**Stephenson Street Flood Defence
Scheme, Newport, Wales**

**S38 and S278 Stage 1 Road Safety
Audit**

ARP-RP-RSA-01

Issue | 28 January 2021

Figure 3: Problem Location Plan 2 of 3

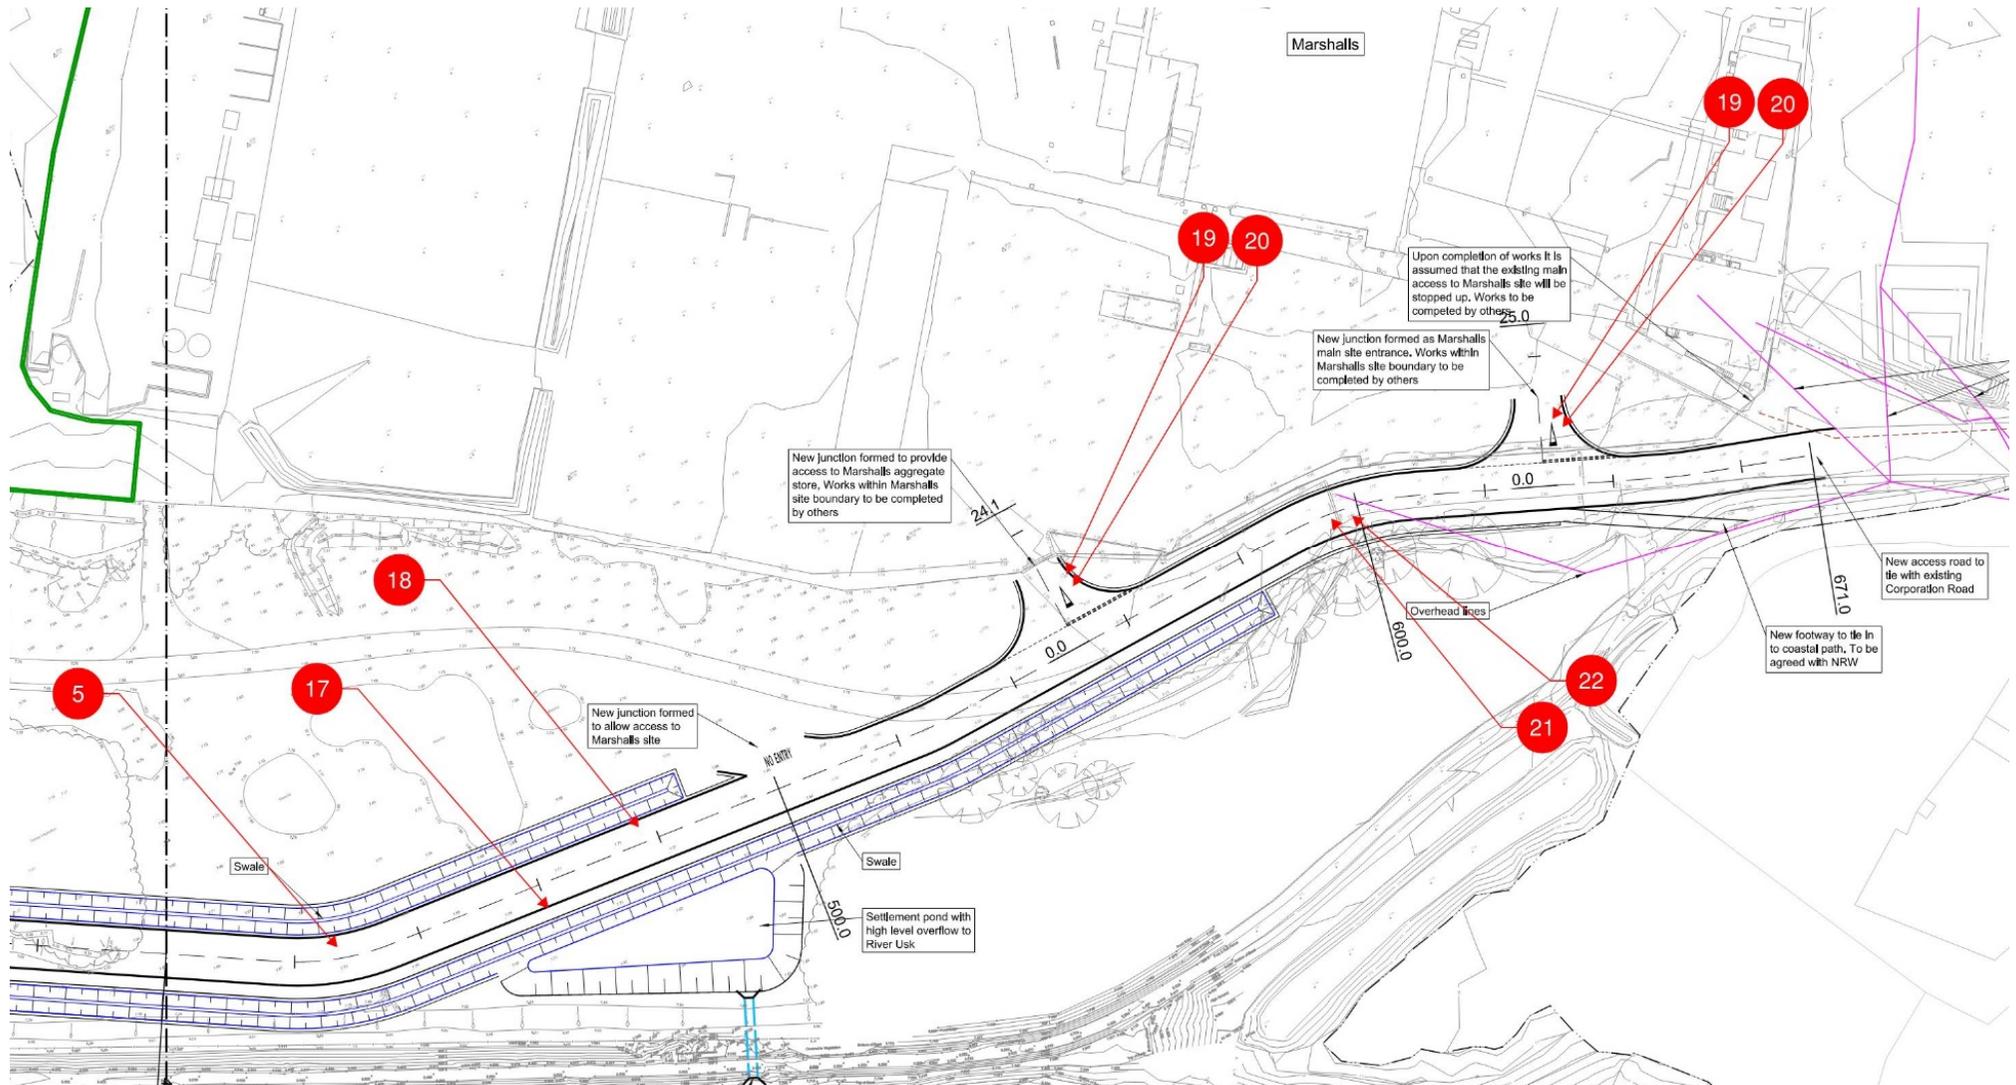
Location:	East Bank Road ch 0+190
Drawing(s):	274580-ARP-XX-XX-DR-CX-1101
Summary:	Long bellmouth increases the risk of a pedestrian being hit by HGV.
Problem:	<p>The main Hanson site access is about 20m across the bellmouth. From a northerly direction, pedestrians would have to cross East Bank Road (ch 130-160) and then cross the bellmouth.</p> <p>The Hanson access would cater for HGVs and pedestrians could be midway across the bellmouth when the HGV driver wishes to turn. Pedestrians could be struck by a turning HGV if the driver fails to see them.</p>
Recommendation:	Extend the footway on the far side of East Bank Road to overcome the need to cross the bellmouth at the main Hanson site access.

Location:	East Bank Road chainage 0+190
Drawing(s):	274580-ARP-XX-XX-DR-CX-1130
Summary:	Insufficient turning space leading to turning and reversing conflicts.
Problem:	<p>The swept path analysis excludes an HGV turning right into the access.</p> <p>Inadequate turning space may lead to collisions between opposing HGVs. If opposing HGVs are unable to turn at the same time, one of HGVs may need to reverse with a risk of colliding with other road users.</p>
Recommendation:	Demonstrate that the turning space at the Hanson main access is adequate to accommodate all possible HGV turning movements.

Location:	East Bank Road, chainage 0+280
Drawing(s):	274580-ARP-XX-XX-DR-CX-1101 274580-ARP-XX-XX-DR-CX-1130
Summary:	Insufficient carriageway width leading to head-on collisions.
Problem:	<p>The road markings imply that the Hanson access to Marshalls would be one-way but the swept path analysis is for two-way. The swept path analysis shows that the width of the access would be too narrow for two-way HGVs.</p> <p>Two-way HGVs would collide head-on. Avoid collision would require one of the HGVs to reverse with a risk of collision with other road users.</p>
Recommendation:	Provide sufficient road width to cater for the required manoeuvres. The road markings should be consistent with the intended use.

Location:	East Bank Road ch 0+285
Drawing(s):	274580-ARP-XX-XX-DR-CX-1130
Summary:	HGVs straddle the centre lines with a risk of head-on collisions.
Problem:	<p>The swept path analysis shows that HGVs turning left in to and out of the access would not be able to turn at the same time. The swept path analysis excludes HGVs turning right. Traffic data is not included in the RSA brief and, with the new road in place, traffic redistribution from Corporation Road may increase traffic flows on East Bank Road.</p> <p>Should HGVs need to turn left and left out at the same time, the HGV entering the site would wait for the HGV exiting the site to clear the junction. A driver behind the waiting HGV may try and overtake and could collide with the HGV exiting the site. The risk of collision would be greater if the road is busier.</p>
Recommendation:	Enlarge the turning area so that left-turning HGVs could enter and exit the site at the same time. Demonstrate that the turning space at the access is adequate to accommodate right-turning HGVs.

Location:	East Bank Road ch 0+480
Drawing(s):	274580-ARP-XX-XX-DR-CX-1102 274580-ARP-XX-XX-DR-CX-1121 274580-ARP-XX-XX-DR-CX-1151
Summary:	Lack of protection to swale and basin increases the severity of injury if collision occurs.
Problem:	<p>The proposed swale and basin are located about 20m from a bend. The invert level of the culvert under the road is 0.8m higher than mean spring high water (MSHW) and the basin is to contain permanent water depth.</p> <p>A driver losing control on the bend may enter the basin and, at worst, there is a risk of drowning.</p>
Recommendation:	Undertake a risk assessment and provide a vehicle restraint barrier if required.

Location:	East Bank Road ch 0+490
Drawing(s):	274580-ARP-XX-XX-DR-CX-1121 274580-ARP-XX-XX-DR-CX-1151
Summary:	Lack of culvert protection increases severity of injury if a collision occurs.
Problem:	The proposed culvert includes indicative wing walls and is located about 80m from a bend. A driver losing control on the bend and hitting a concrete wingwall could be severely injured.
Recommendation:	Undertake a risk assessment for the proposed culvert wingwalls and provide vehicle restraint if required.

Figure 4: Problem Location Plan 3 of 3

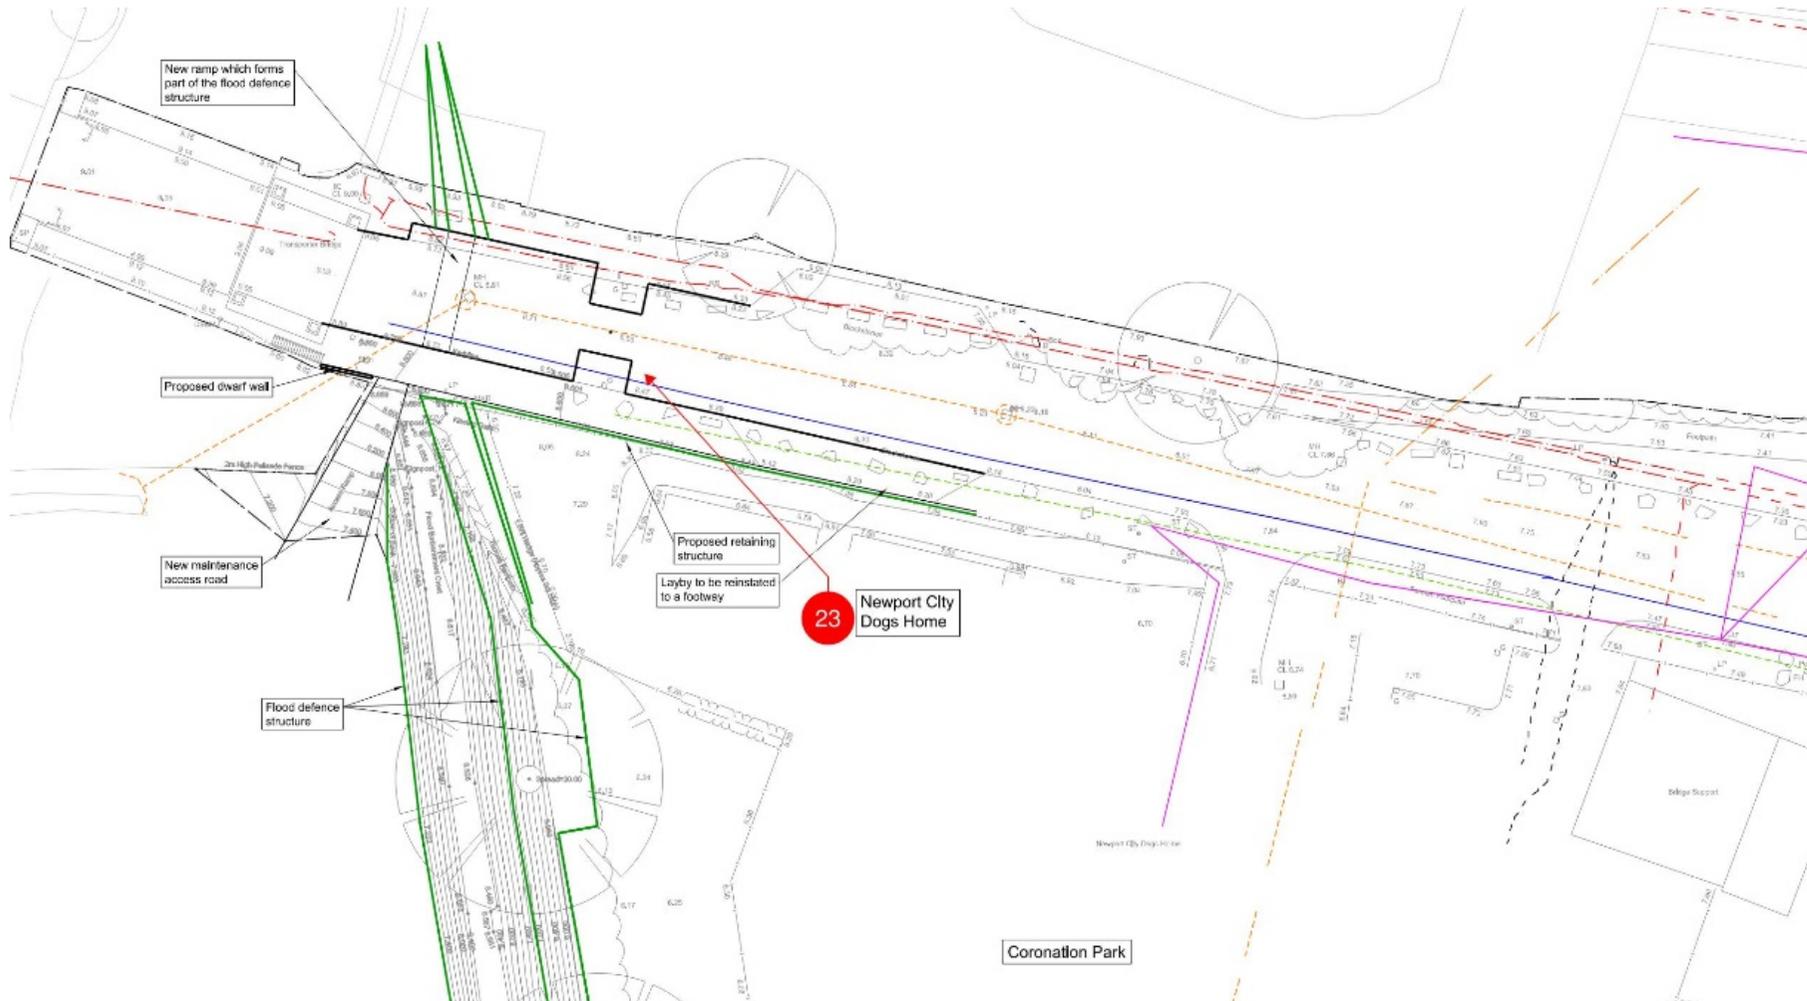
Location:	East Bank Road ch 0+550 and 0+630
Drawing(s):	74580-ARP-XX-XX-DR-CX-1111
Summary:	Inadequate queueing space at the gates leading to collisions on East Bank Road.
Problem:	The length of queueing space between the edge of East Bank Road carriageway and the gates at the boundary appear to be shorter than a typical heavy goods vehicle (HGV). HGVs stopped at the gates at the boundary may overhang the edge of East Bank Road carriageway. Through traffic on East Bank Road may collide with the rear end of an overhanging HGV or brake suddenly to avoid collision.
Recommendation:	Reposition the gates at the boundary to increase the length of queueing space between the gate and the edge of East Bank Road carriageway to accommodate the longest vehicle expected to use the access.

Location:	East Bank Road ch 0+550 and 0+630
Drawing(s):	274580-ARP-XX-XX-DR-CX-1131
Summary:	HGVs straddle the centre lines with a risk of head-on collisions.
Problem:	<p>The swept path analysis shows that HGVs turning left in to and out of the new access would not be able to turn at the same time. The swept path analysis excludes HGVs turning right at the access. Traffic data is not included in the RSA brief and, with the new road in place, traffic redistribution from Corporation Road may increase traffic flows on East Bank Road.</p> <p>Should HGVs need to turn left in and left out at the same time, the HGV entering the site would wait for the HGV exiting the site to clear the junction. A driver behind the waiting HGV may try and overtake and could collide with the HGV exiting site. The risk of collision would be greater if the road is busier.</p>
Recommendation:	Enlarge the turning area so that left-turning HGVs could enter and exit at the same time. Demonstrate that the turning space at the accesses is adequate to accommodate right-turning HGVs.

Location:	East Bank Road ch 0+600
Drawing(s):	274580-ARP-XX-XX-DR-CX-1140
Summary:	Lack of swept path leading to front offside collisions.
Problem:	<p>The swept path analysis does not show opposing HGVs on the bend at chainage 600.</p> <p>There is a risk of front offside collisions if one or both of the opposing HGVs straddle the centre line.</p>
Recommendation:	Demonstrate that the carriageway is wide enough to accommodate opposing HGVs. If necessary, provide carriageway widening to ensure that HGVs can pass safely.

Location:	East Bank Road ch 0+600
Drawing(s):	274580-ARP-XX-XX-DR-CX-1102 274580-ARP-XX-XX-DR-CX-1104
Summary:	Obscured visibility leading to a variety of collisions.
Problem:	The RSA brief does not include a forward visibility envelope at chainage 0+600. There are existing trees on the inside of the bend that are outside the limits of site clearance. Inadequate forward visibility could lead to collisions with obstructions in the carriageway ahead or sudden braking and loss of control.
Recommendation:	Provide adequate stopping sight distance across the bend. The visibility envelope should be clear of any obstructions such as trees.

Location:	Stephenson Street
Drawing(s):	274580-ARP-XX-XX-DR-CX-1201
Summary:	Cycle lane obstructed by bioretention area leading to cyclist injury.
Problem:	The proposed bioretention areas narrow the carriageway and obstruct the westbound cycle lane. Cyclists may continue into the bioretention area causing them to fall from their bikes and sustain injury.
Recommendation:	Incorporate the cycle lane in the road markings and signage at detailed design stage.
